Anthropomorphic Test Devices; Hybrid III Test Dummy, ES-2re Side Impact Crash Test Dummy

ACTION: Final rule.

SUMMARY: This document corrects or makes minor changes to some of the drawings incorporated by reference into NHTSA regulations by a final rule published on June 16, 2008, concerning a 50th percentile adult male side crash test dummy called the “ES-2re” test dummy. The corrections and adjustments to the drawings respond to requests from test dummy manufacturers First Technology Safety Systems (FTSS) and Denton ATD (Denton). This final rule also corrects dimensional errors in a figure which depicts the pendulum used in the neck qualification tests of several of the crash test dummies, including the Hybrid III and ES-2re test dummies.

Figure 1: Corrections to pendulum dimensions in Figure 22 of Section 572.33(c)(3)

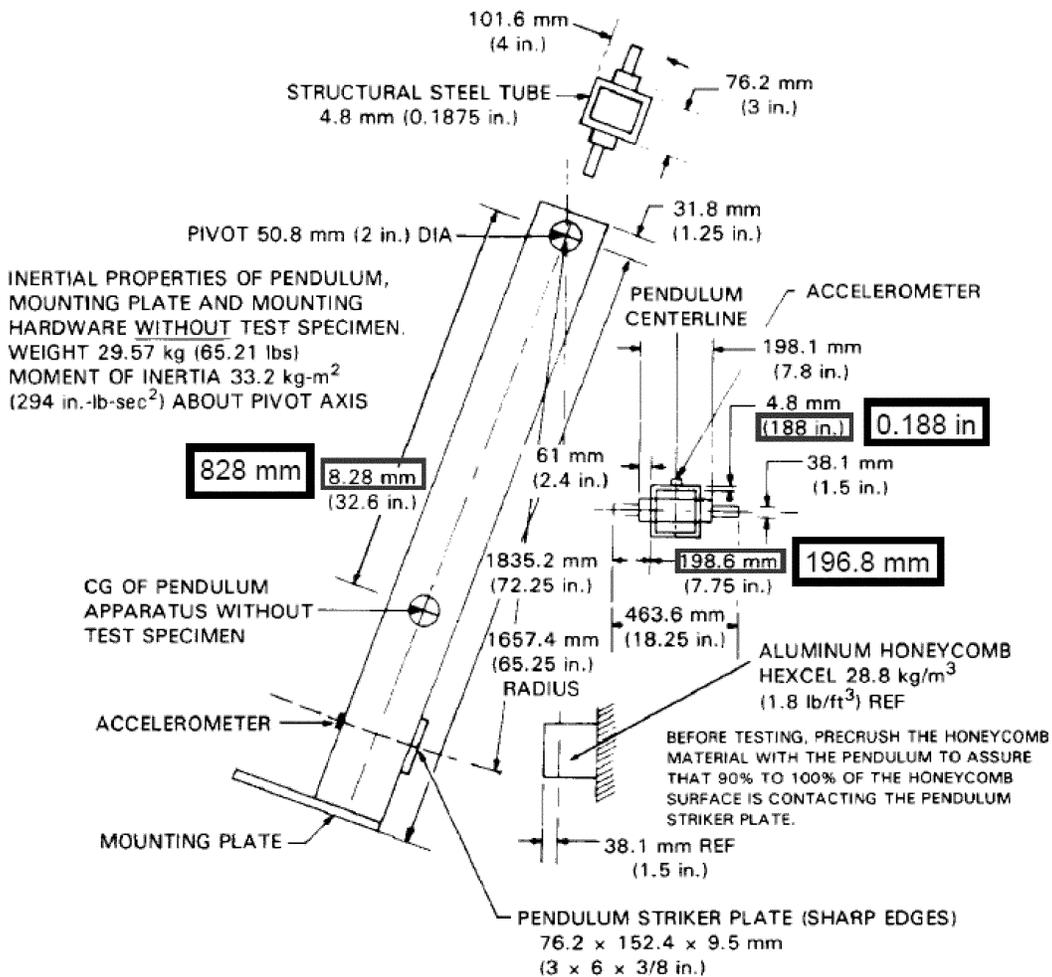
This final rule corrects several dimensional values in Figure 22, “Pendulum Specifications,” of 49 CFR part 572. This pendulum is used in neck qualification tests for the ES–2re as well as other adult crash test dummies, including the Hybrid III 50th percentile male and 5th percentile female frontal crash test dummies, the SID–IIIsD 5th percentile female side impact dummy, and the SID and SID/HIII side impact crash test dummies. The dimensional corrections are listed below and shown in Figure 1 of this preamble, below:

- The 8.28 millimeter (mm) (32.6 inch (in)) dimension is changed to 828 mm (32.6 in);
- The 4.8 mm (188 in) dimension is changed to 4.8 mm (0.188 in);
- The 198.6 mm (7.75 in) dimension is changed to 196.8 mm (7.75 in).

FIGURE 22
PENDULUM SPECIFICATIONS

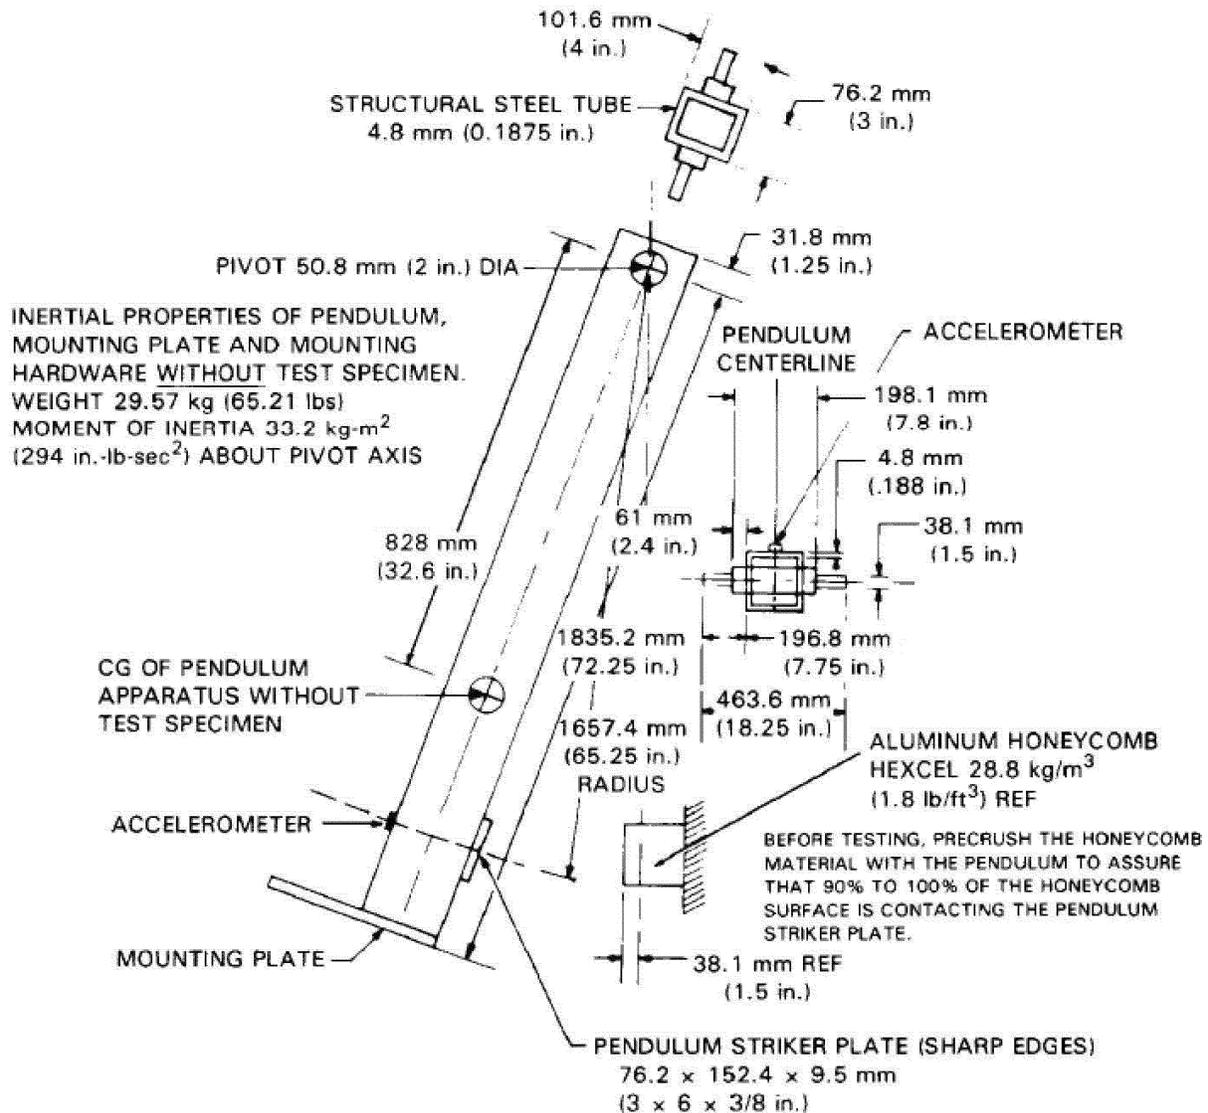
■ 2. In § 572.33(c)(3), Figure 22 is revised to read as follows:
